LiDAR Quality Assessment Report

VA-FEMA Region3-Lot1(Loudoun Co.)
_2012

FEMA Region 3

Bridge error at 39° 15' 4.5892" N, 77° 28' 51.5114" W

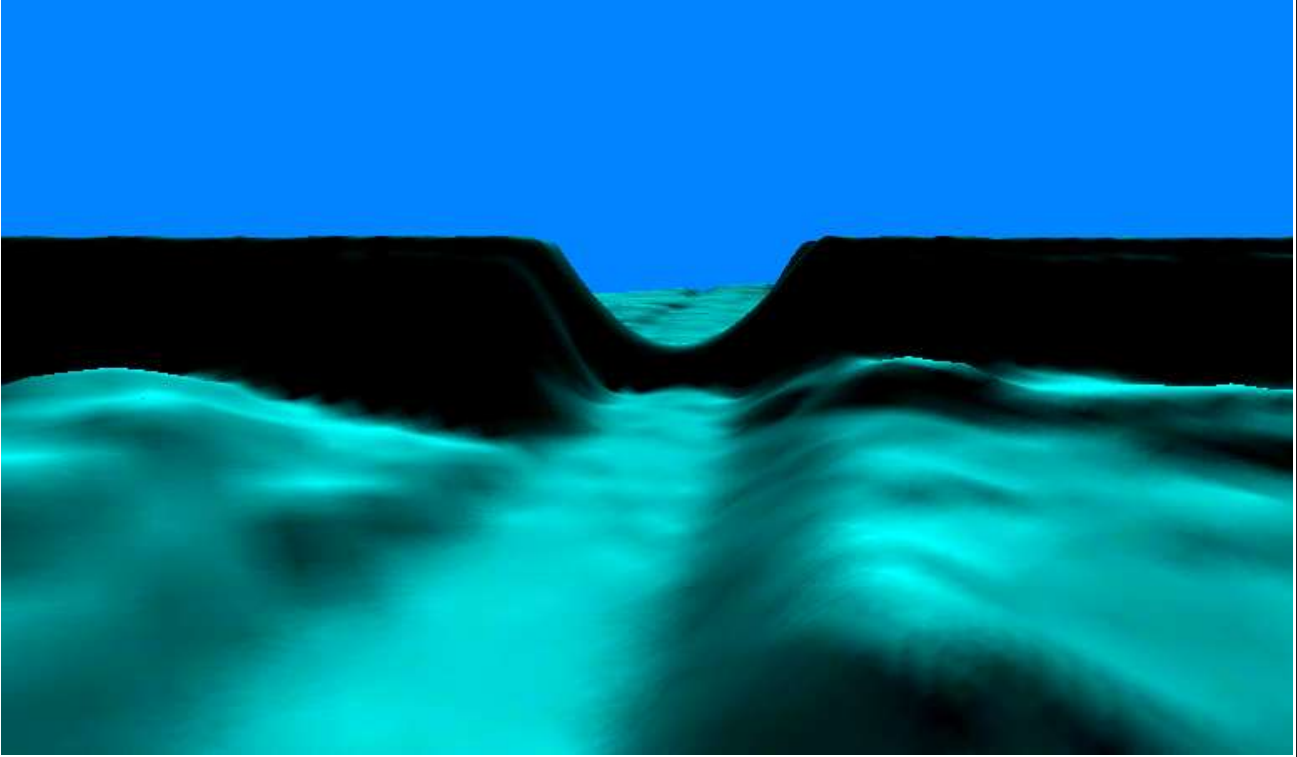
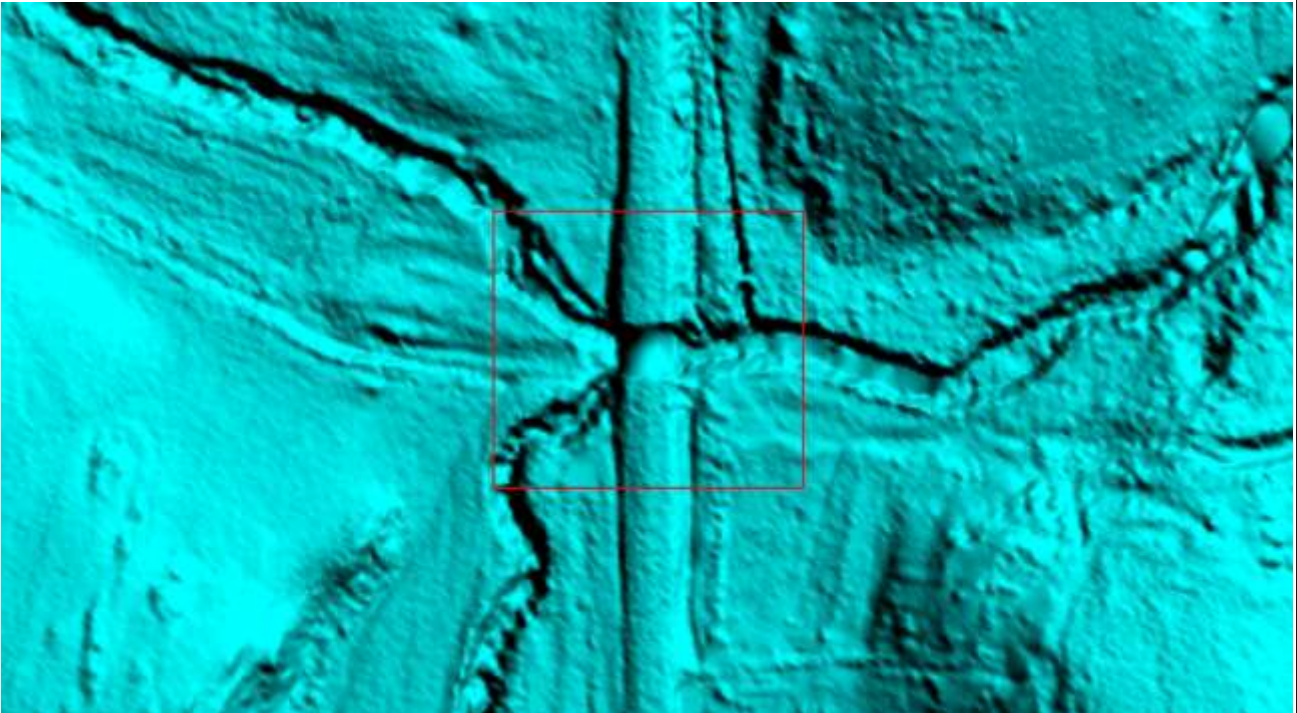
In total, five errors were found in this dataset. All errors were incomplete bridge removals, which Dewberry will not fix.

Above error in 3D

Bridge error at $39^{\circ} 10' 3.3633''$ N, $77^{\circ} 32' 10.1629''$ W

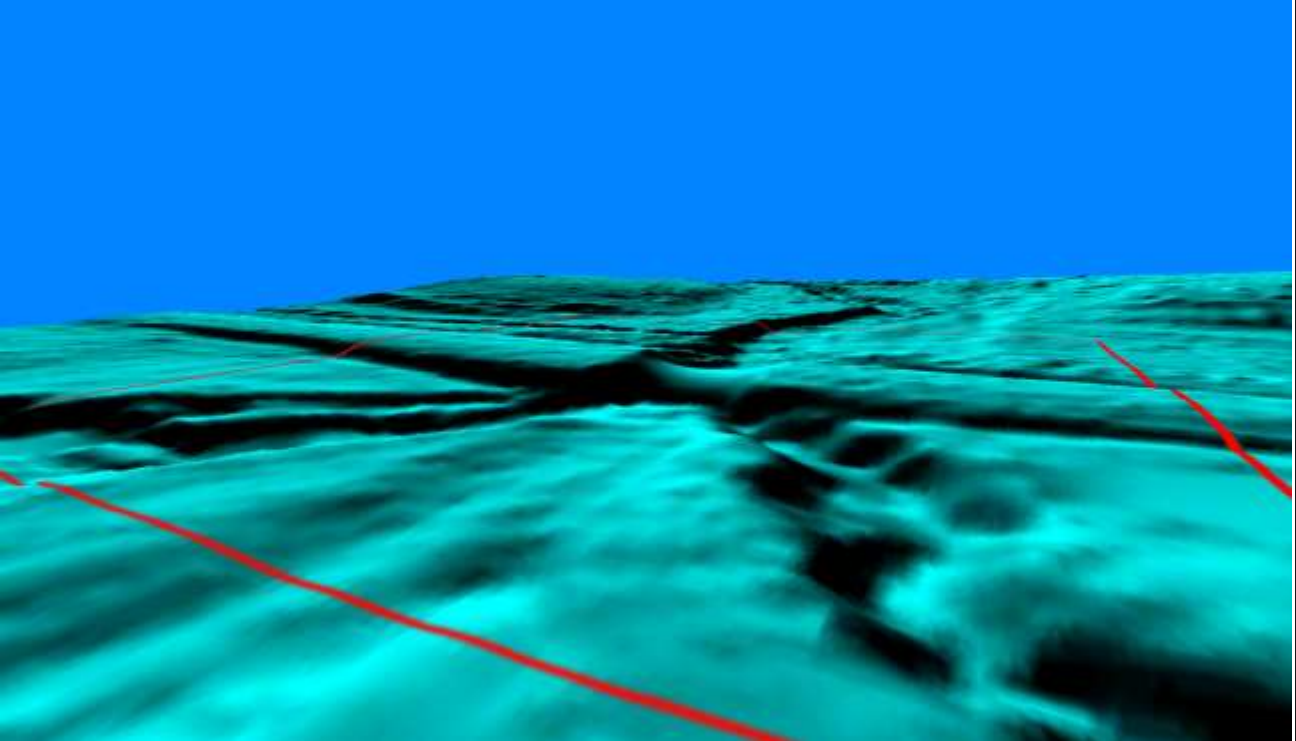
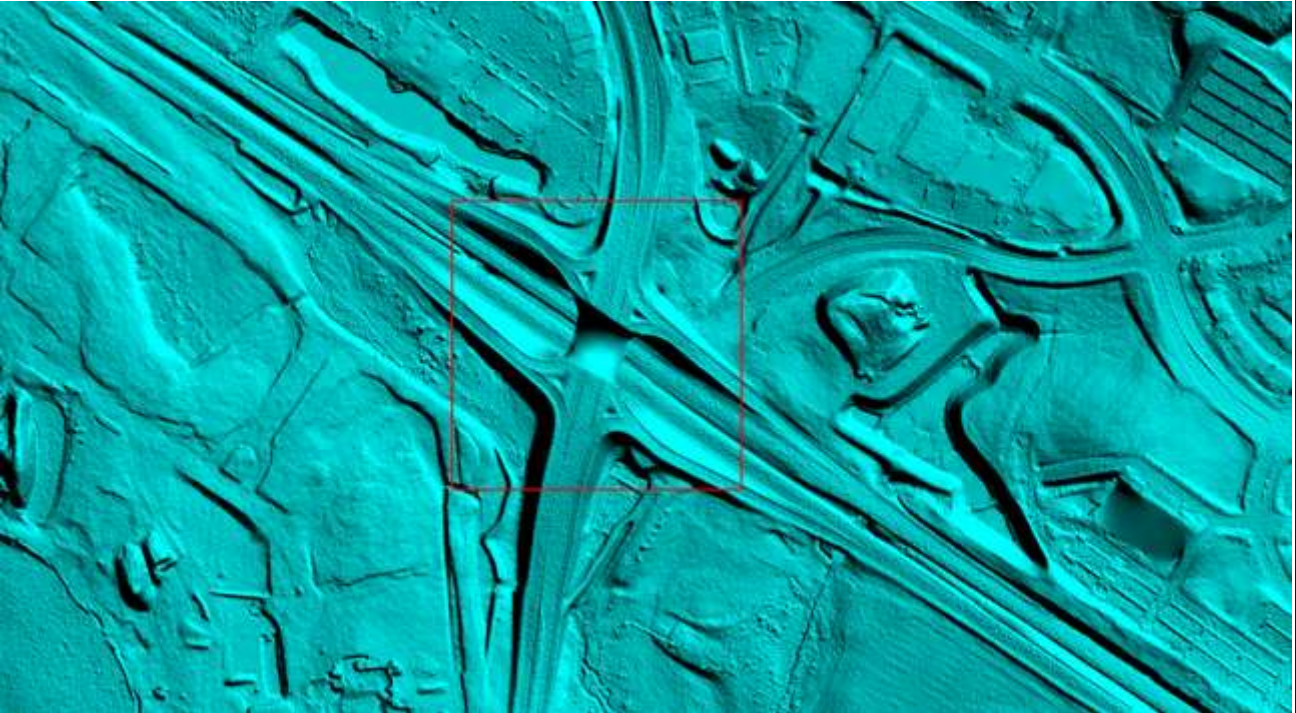
Above error in 3D

Bridge error at $39^{\circ} 03' 22.3106''$ N, $77^{\circ} 27' 3.0153''$ W

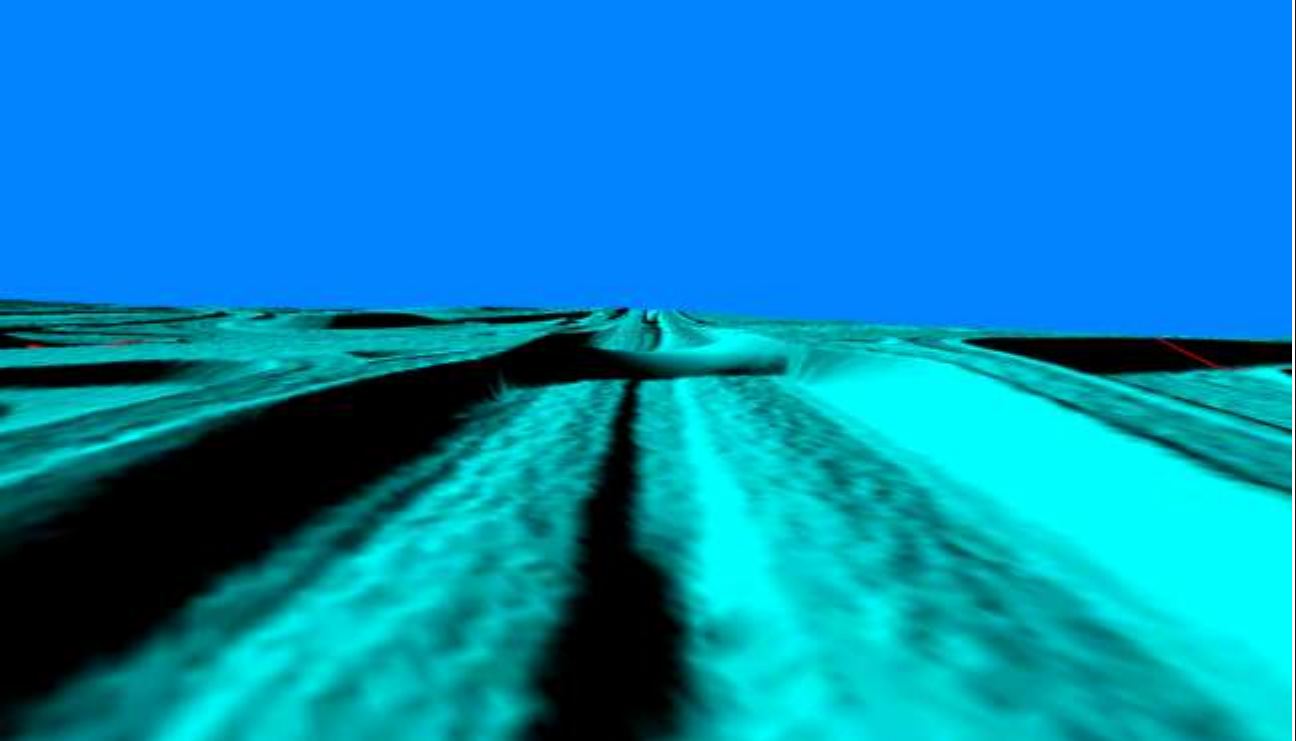
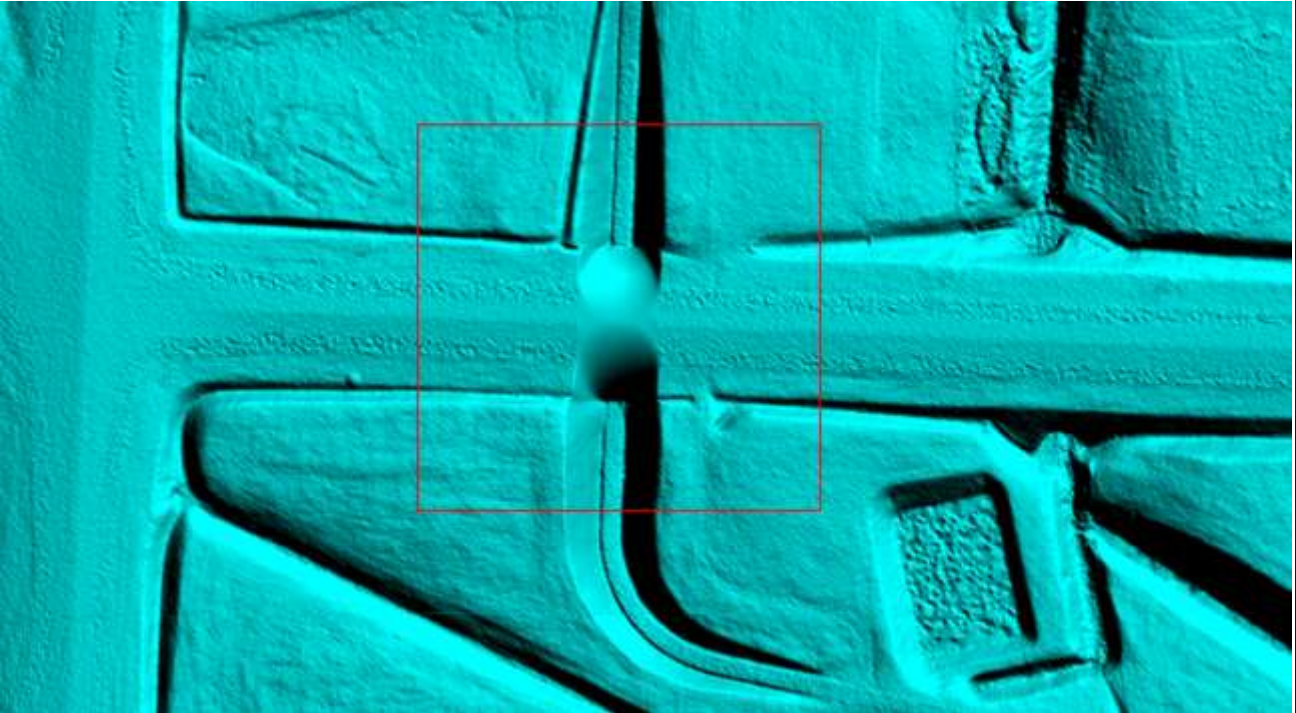
Above error in 3D

Bridge error at $38^{\circ} 57' 1.8704''$ N, $77^{\circ} 28' 8.8984''$ W

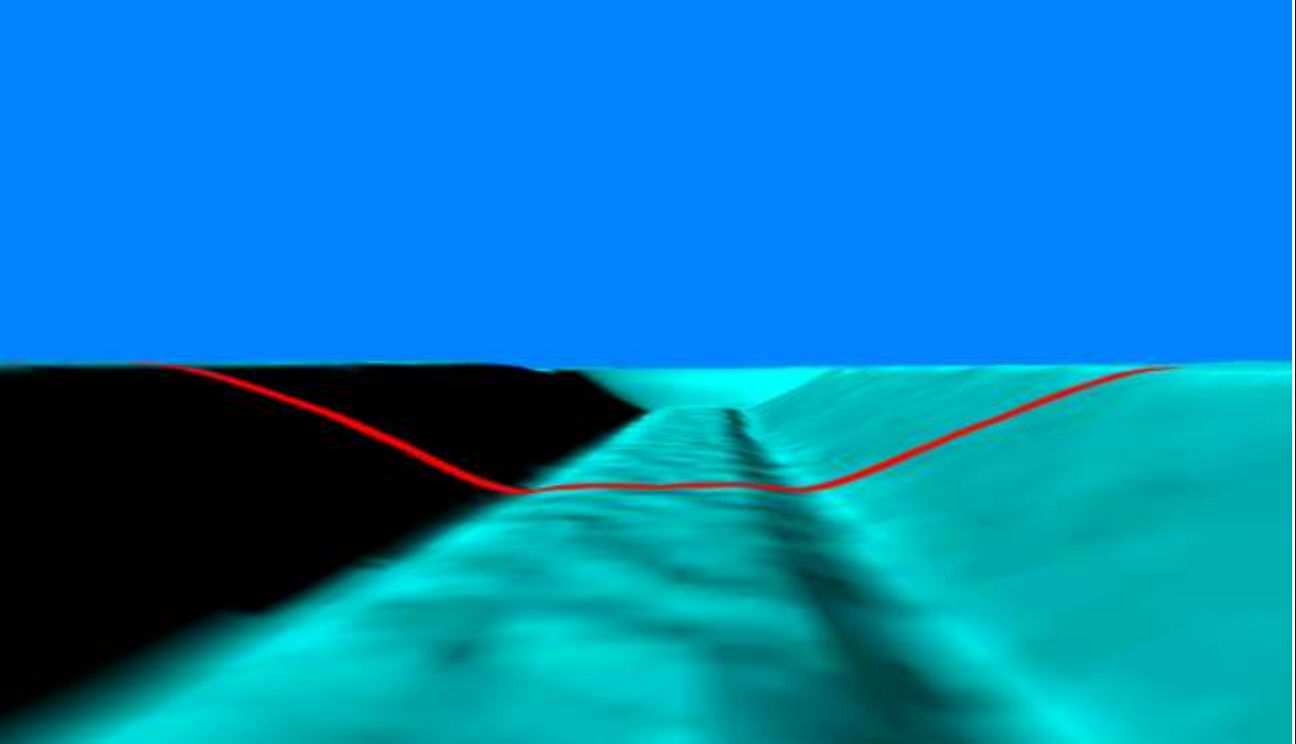
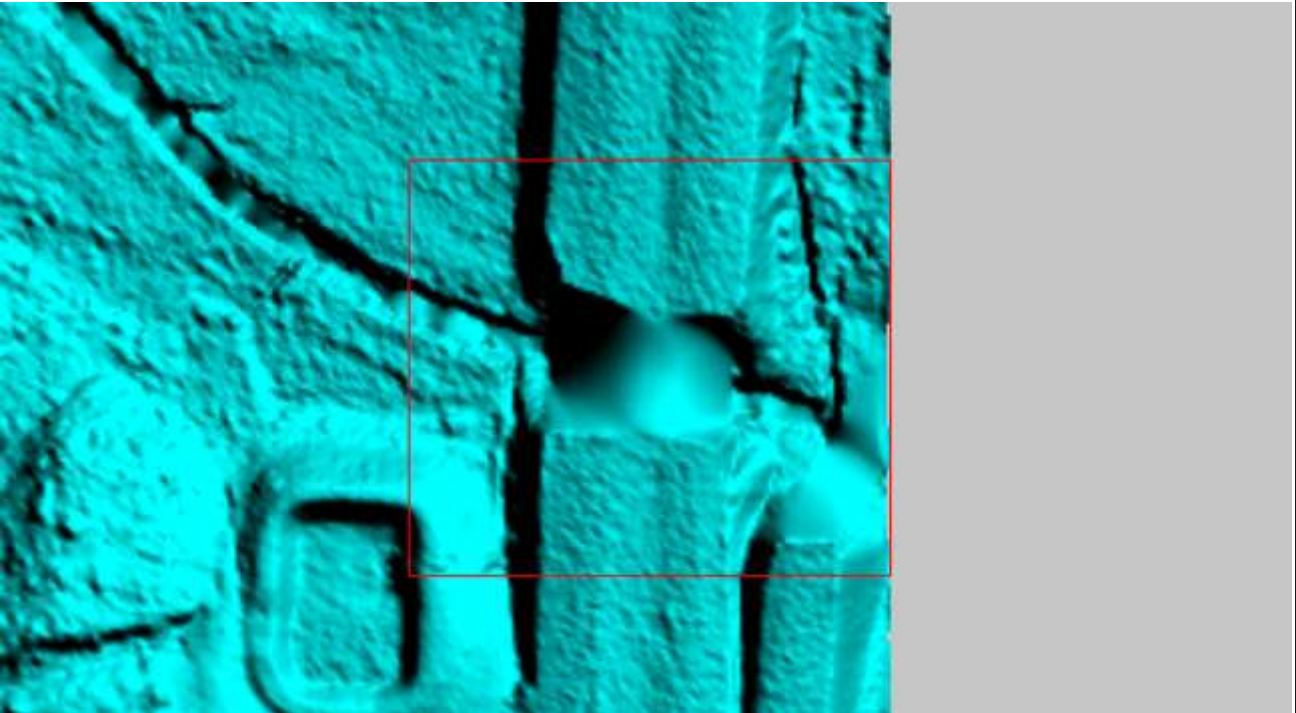
Above error in 3D
